Islam Garments Ltd. (Knitwear Division)

20 June 2022

Building-7: Partially seven storied (G+M+6) reinforced concrete (RC) building.

Observations

Column layout plan

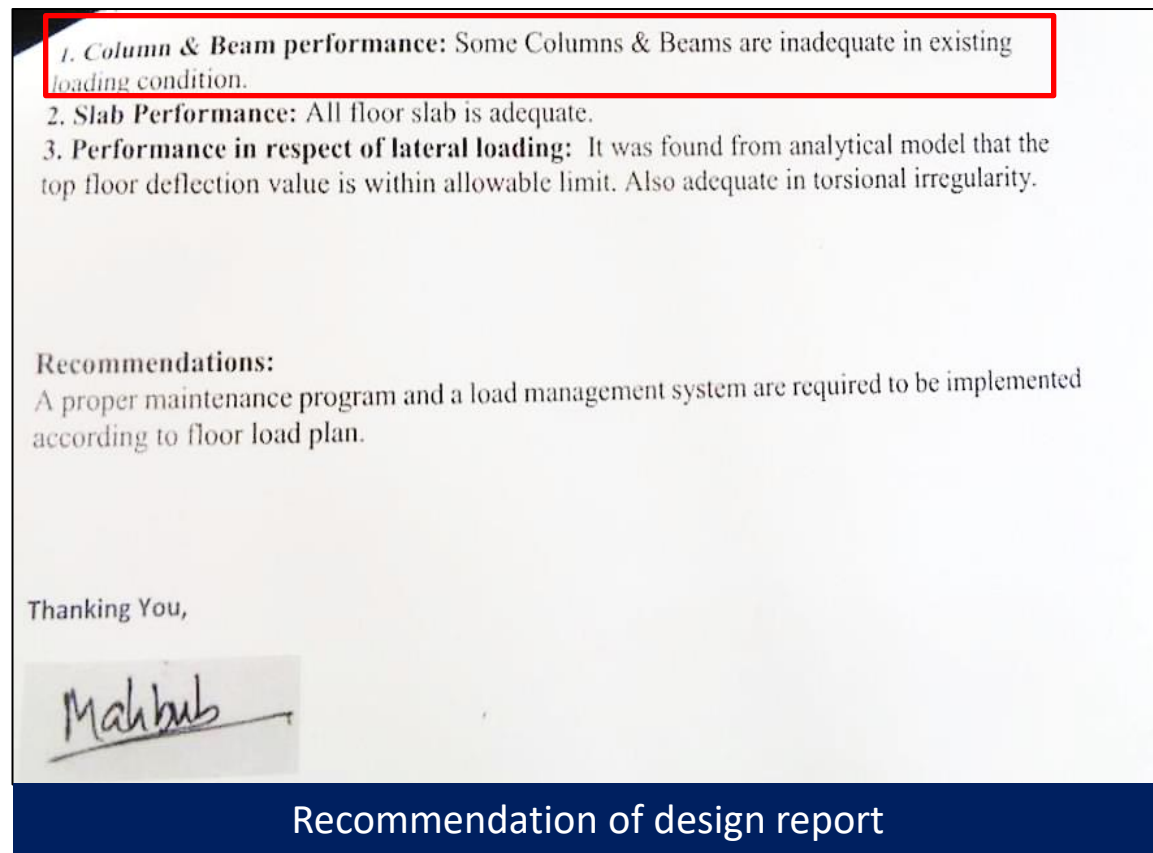
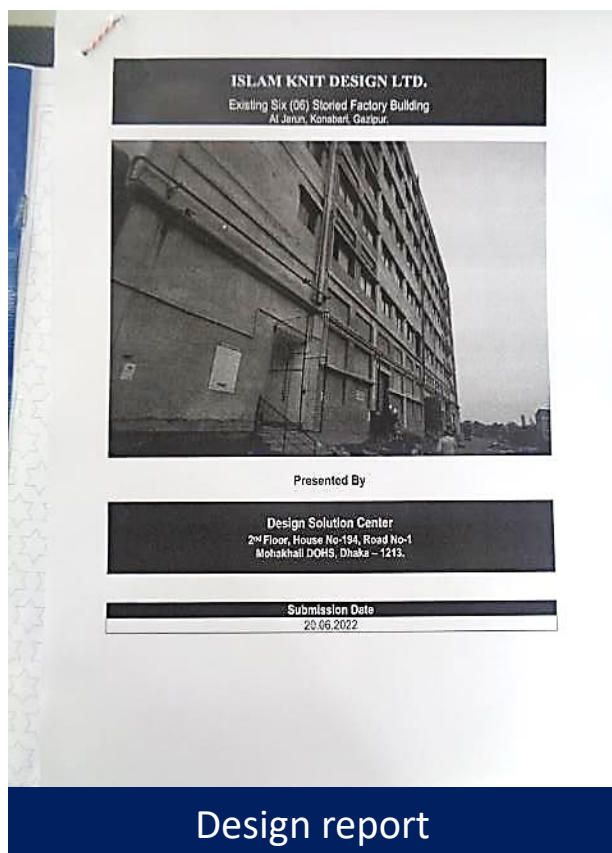
Column stress exceeds normal design limit

Load comes from the OHWT

Cursory calculation indicates that factor of safety (FoS) of column at north-west staircase is below the allowable limit considering the floor live load 3 kPa for typical floor, 4 kPa for stair area, 1.5 kPa for roof and super imposed load from brick walls and overhead water tank. Building engineer is required to review the design, loads and column stresses and suggest a proper remediation scheme.
